Background:

Consideration of Comments on Second Draft of Frequency Response SAR

Figure 1 Original Eastern Interconnection Frequency Response Study (Ingleson and Nagle)

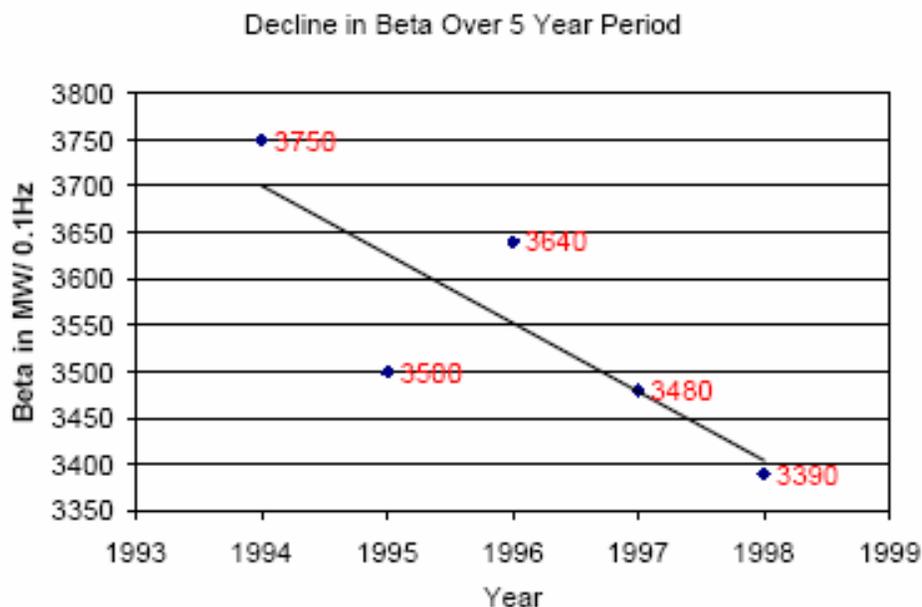
The original SAR on Frequency Response was submitted in large part due to a study that showed a 10+% decline in Eastern Interconnection Frequency Response over a 5 year period, when response should be increasing over time as an Interconnection grows. The drafting team posted a whitepaper along with the SAR to outline the need for a standard.

Figure 2 Updated Eastern Interconnection Frequency Response (NERC Resources Subcommittee)

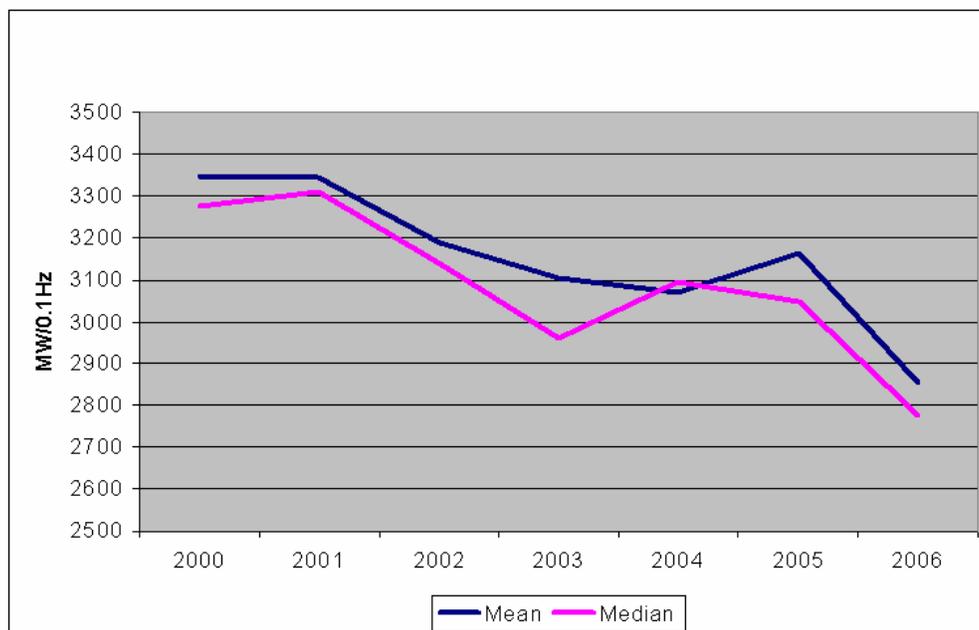
The NERC Resources Subcommittee recently updated their estimate of Eastern Interconnection Frequency Response and found it to be on the order of 2800MW/0.1Hz and still trending downward.
